Peer Review of Soakage System for Proposed Wallaceville Residential Development

Wellington Water

• June 2015

FIGURE 1: MONITORING WELL, TEST PITS AND PROPOSED SOAKAGE BASINS

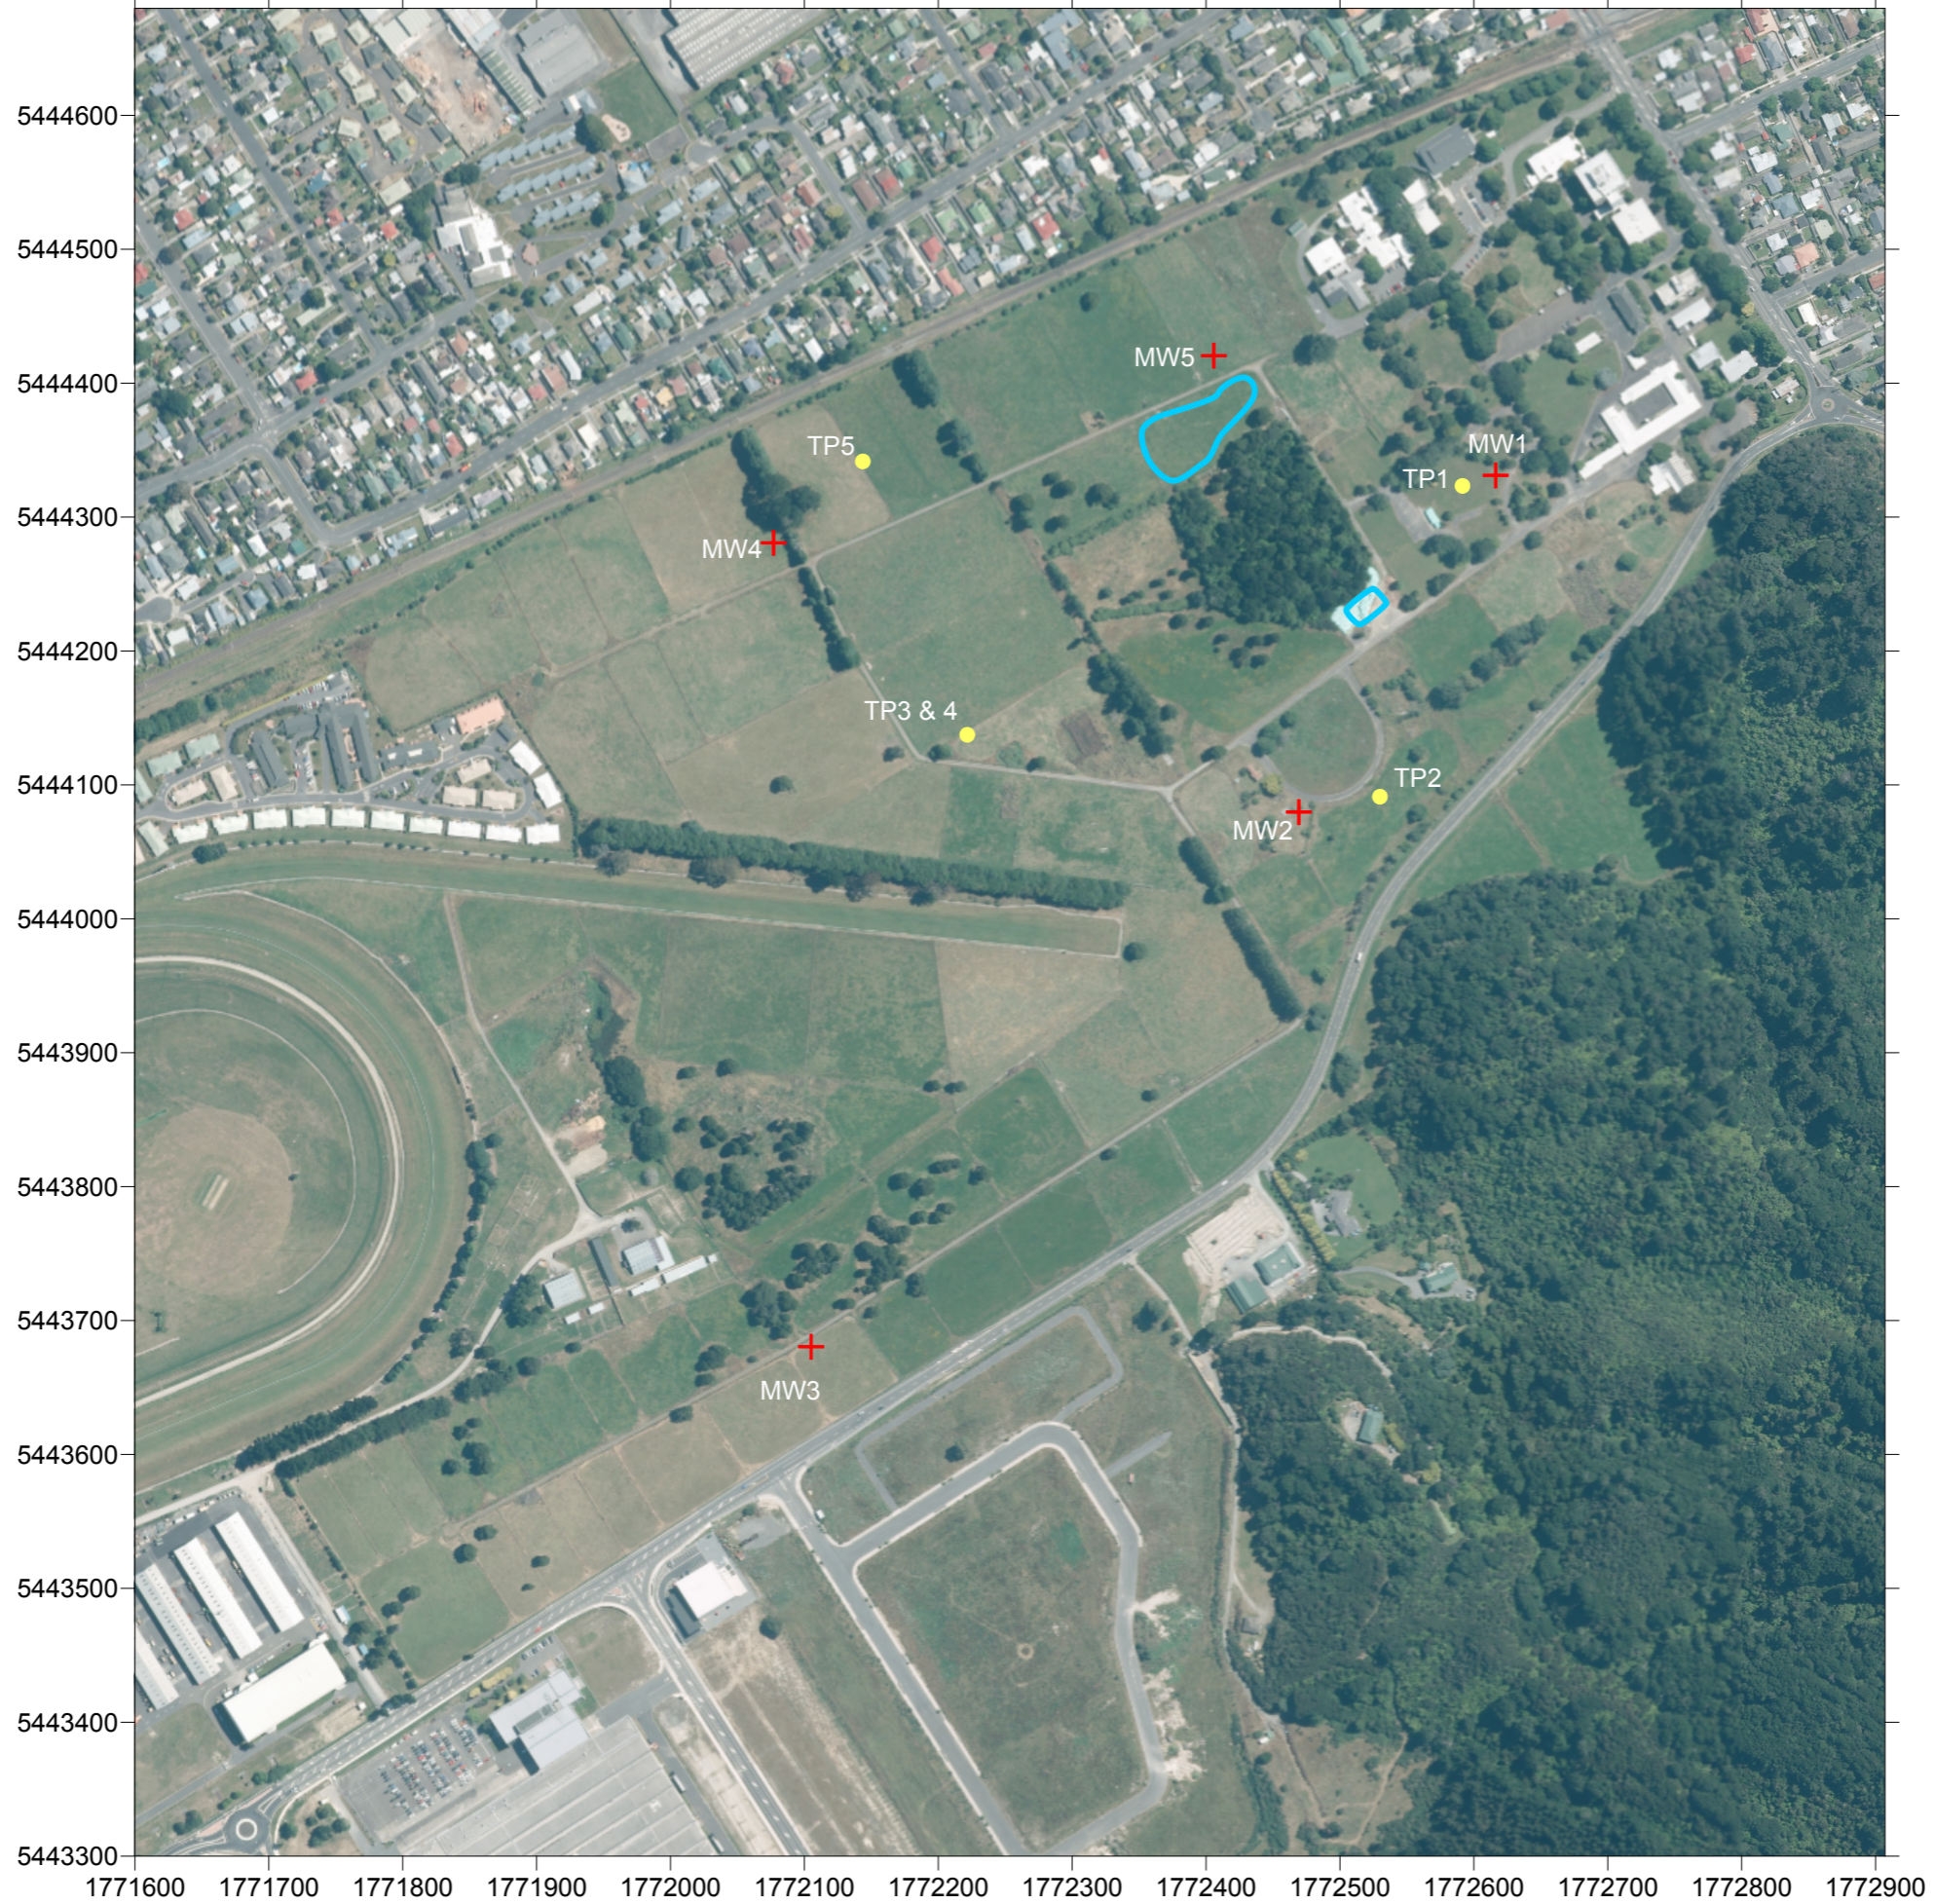
Five monitoring wells were installed at depths of 10 to 11 m as part of the investigations. The locations of these are shown in Figure 1. The Applicant's consultant has provided groundwater levels and borehole logs, but no other hydrogeological information.

The northernmost basin is proposed to be installed to the south of monitoring well MW5. Although depth to groundwater is quite large (≥ 8.5 m during the period of measurement), if the permeability is sufficiently low groundwater mounding could occur. Analysis of rainfall events recorded at Trentham Racecourse over the past 35 years indicates that daily rainfall events of > 40 mm occur 5 to 6 times per year, on average. It is feasible that during a particularly wet period, groundwater levels could rise significantly. It is therefore recommended that hydraulic testing and analytical mounding calculations are undertaken to verify that mounding will not occur to a level that would impact on the operation of the soakage basin.

Figure 2: Rainfall data (at Trenham Racecourse) and groundwater levels in five monitoring wells.

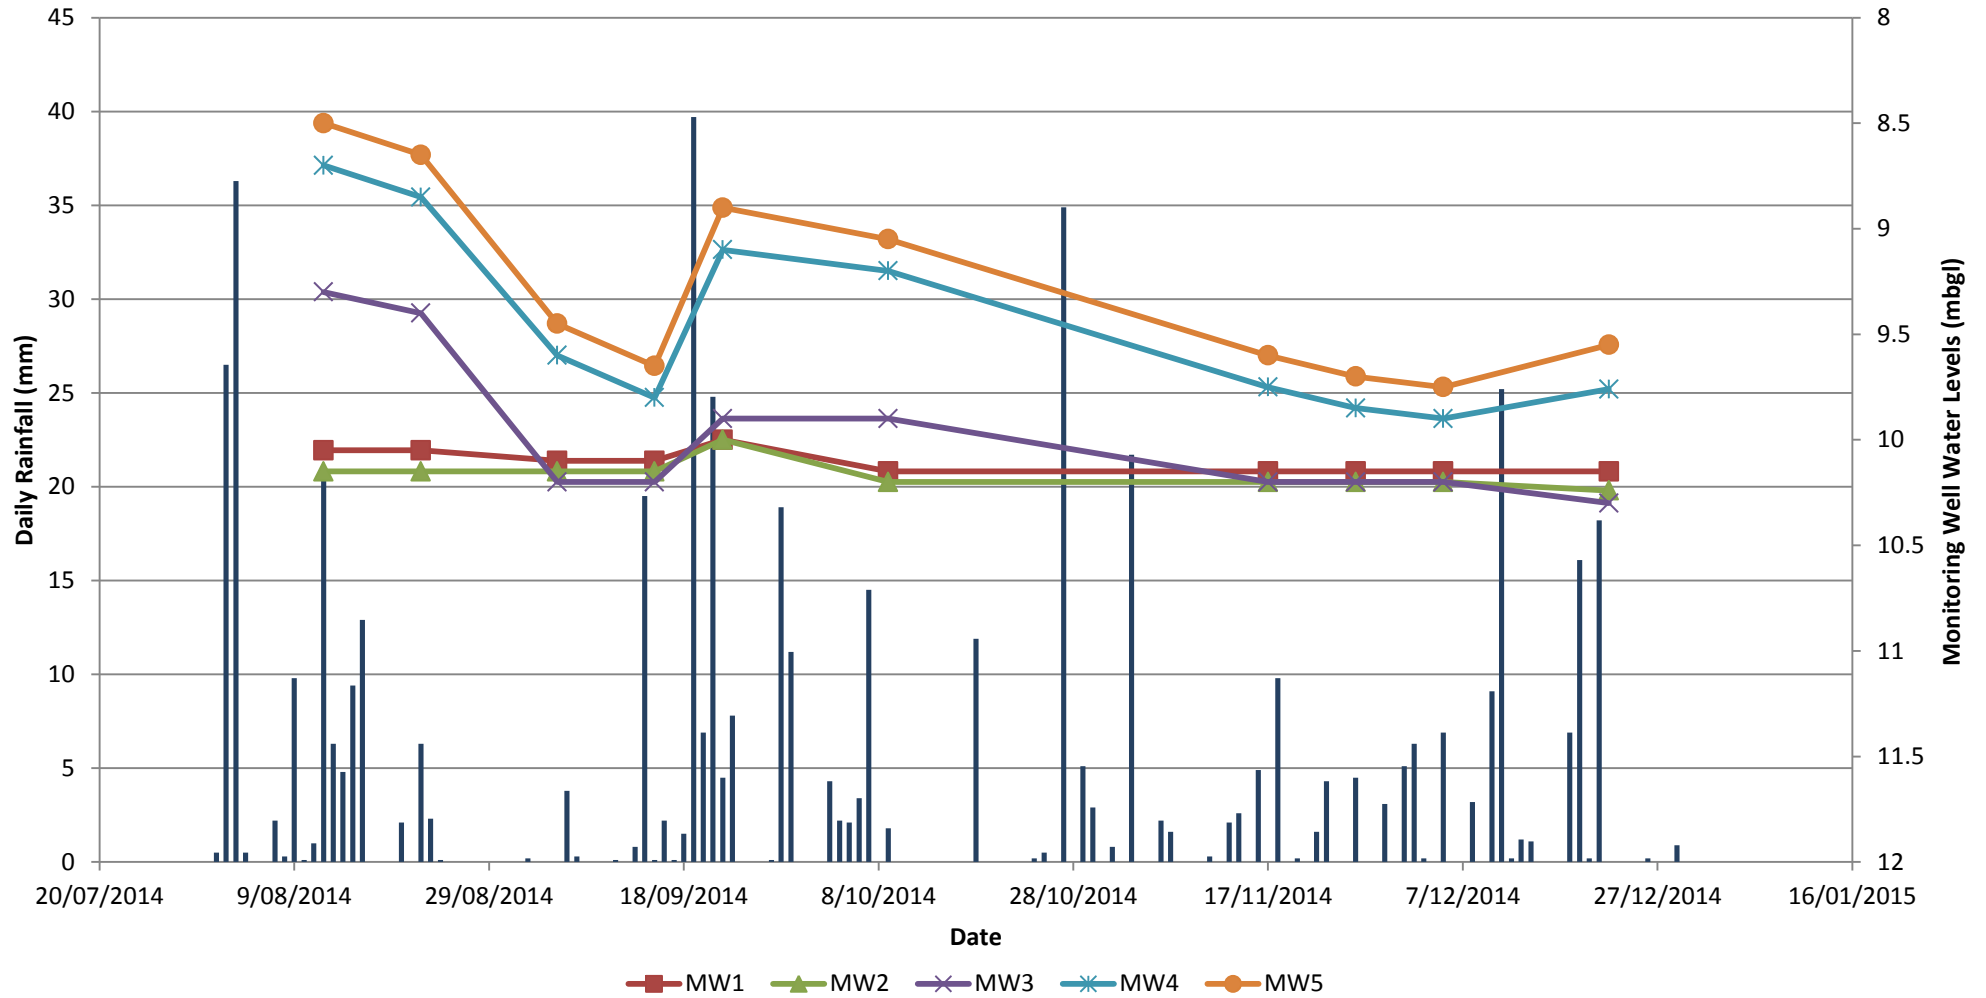
Groundwater levels were recorded on ten occasions over five months between 12 August 2014 and 22 December 2014. Groundwater levels in monitoring wells MW1 and MW2, located to the east and south of the site, respectively, are relatively consistent throughout this period at around 10 to 10.2 m bgl (below ground level). However, groundwater levels in MW3, MW4 and MW5 are more variable. Levels declined by approximately 1 m in these bores over approximately a one month period from August to September, before rising by up to 0.75 m (in MW5) over a seven-day period in September 2014.

This rapid rise in groundwater level correlates with a 39.7 mm rainfall event on 19 September 2014. Rainfall occurred on each of the previous six days and the event was followed by three more days of rainfall. Between the two monitoring dates on 15 September and 22 September a total of 79.7 mm of rainfall occurred. The groundwater levels and rainfall are shown on Figure 2.

The rapid response time suggests that rainfall recharge could be as important as recharge from the Hutt River at this location. In the conceptual model, the Applicant's consultant has stated that only 5 % of recharge to the unconfined aquifer will be from rainfall. However, this value is likely to be only valid close to the Hutt River. Away from the river, a much greater proportion of rainfall recharge should be expected.

Such a large fluctuation of groundwater level could be indicative of a relatively low permeability formation. Borehole logs indicate that all of the bores are

Date	04/06/15	Client	Wallaceville Development		
Drawn by	HW	Project	Response to Request for Further Information; Wallaceville Soakage System		
Approved by	GC	Description	Conceptual Hydrogeological Model		
Scale	NTS	Figure Number	2	Project Number	11307

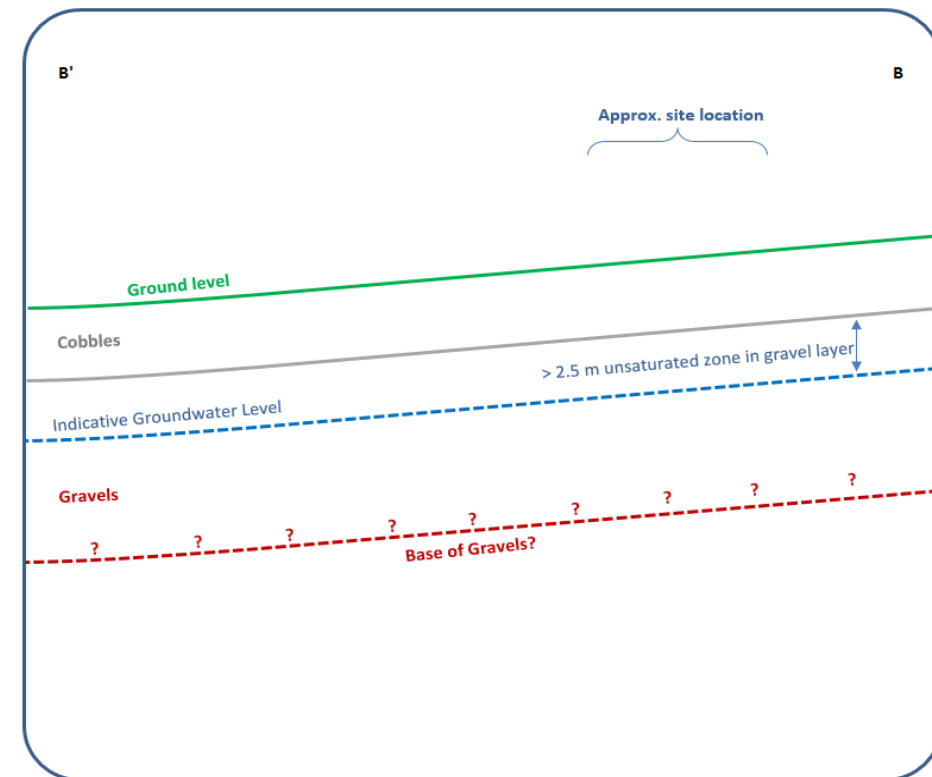
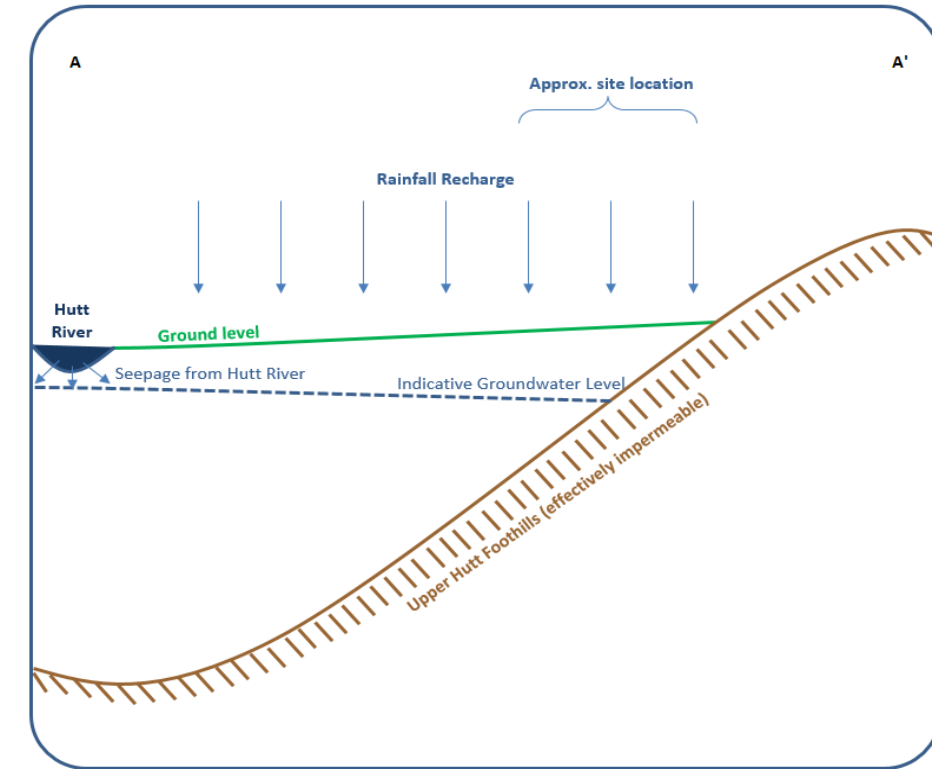
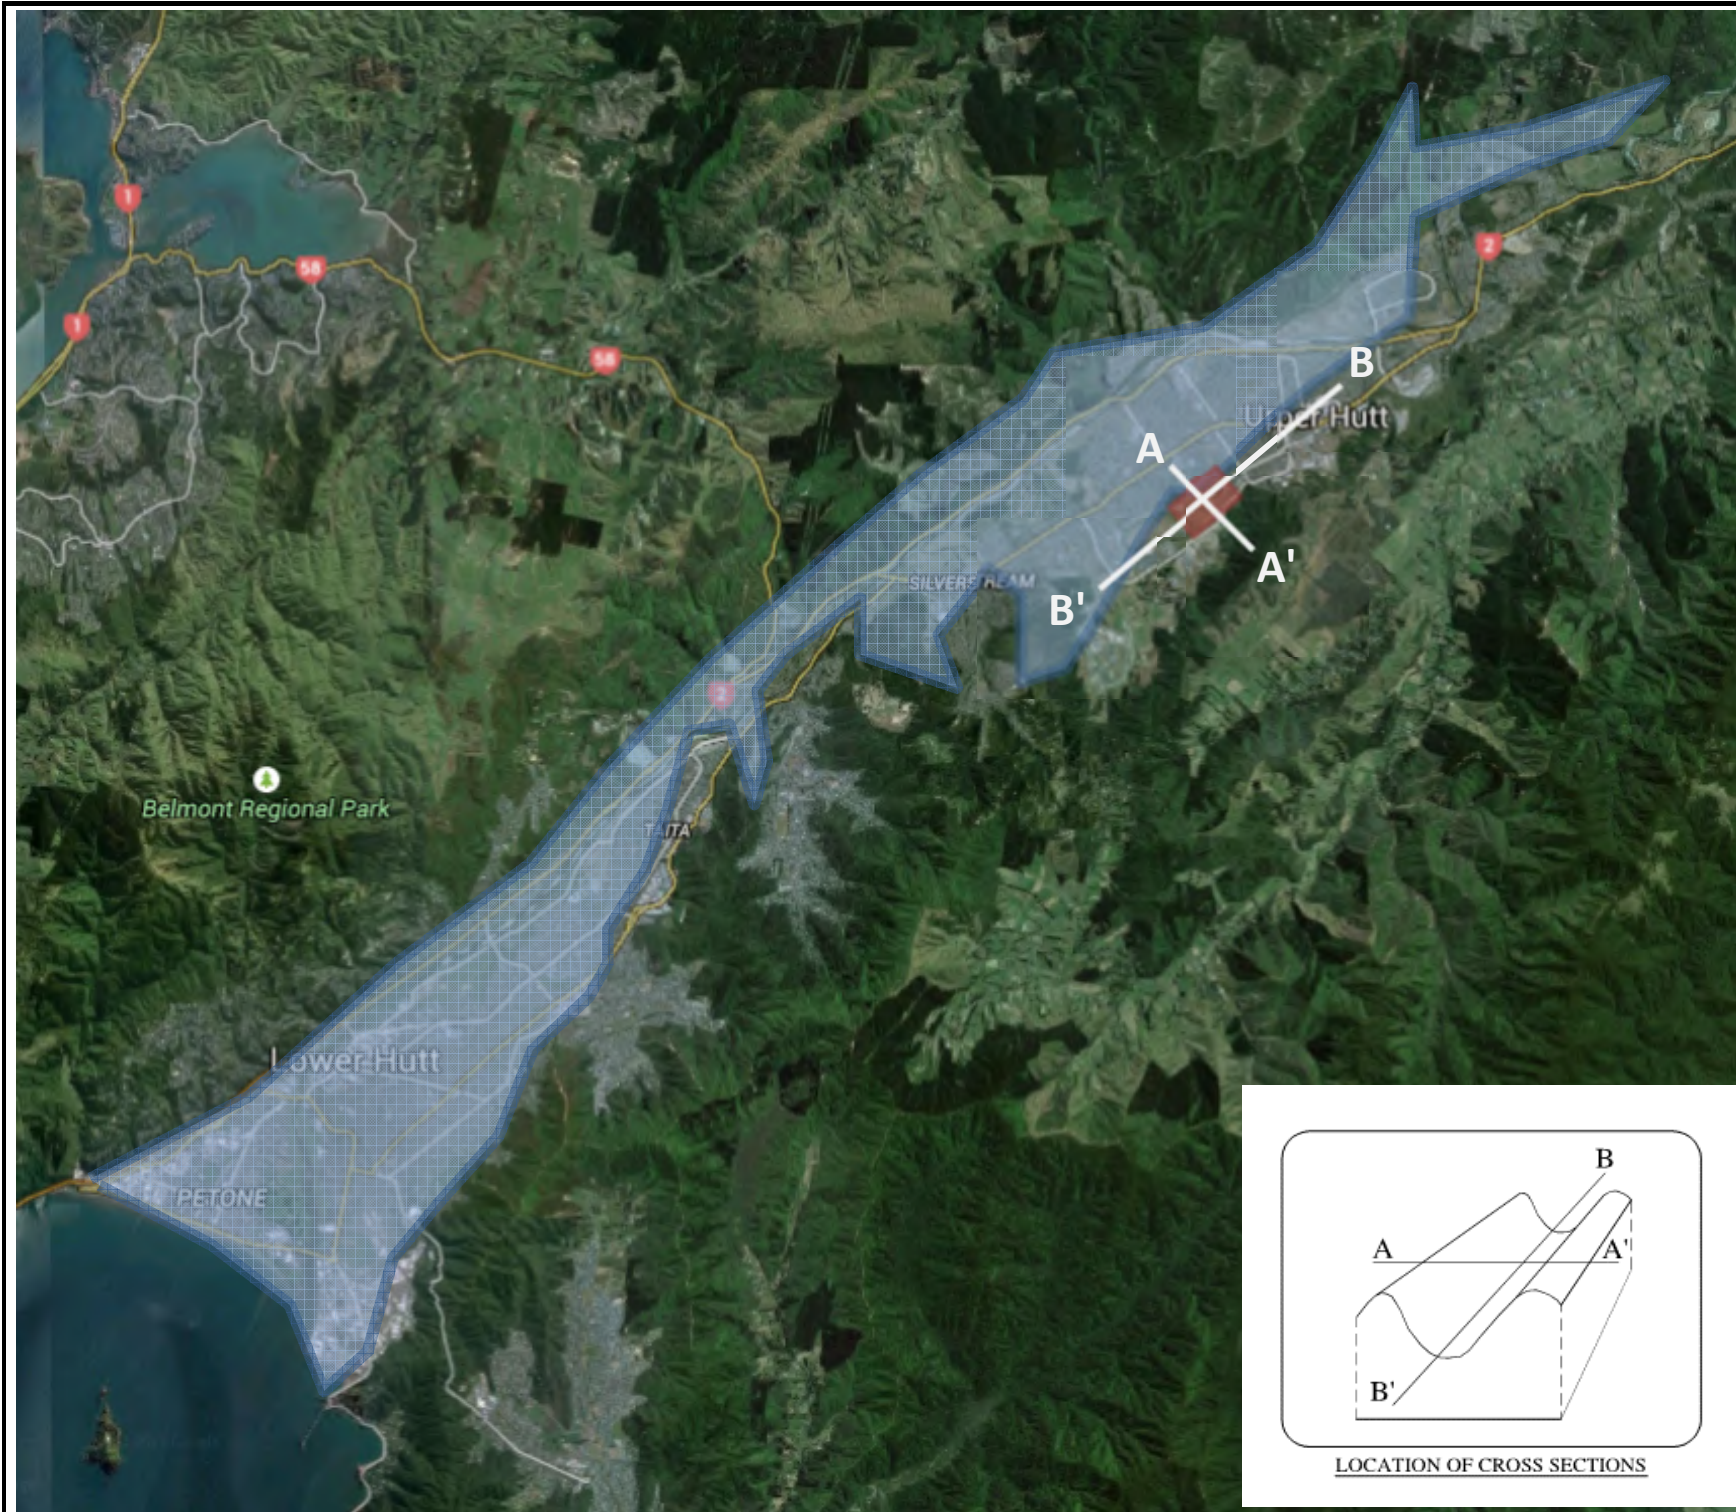
Whilst PDP agrees with this conclusion, cross section A – A' of Figure 2 in ENGEO's response to PDP's request for further information (attached) shows groundwater flowing in the opposite direction to the topographical gradient. This is misleading and should be amended accordingly.
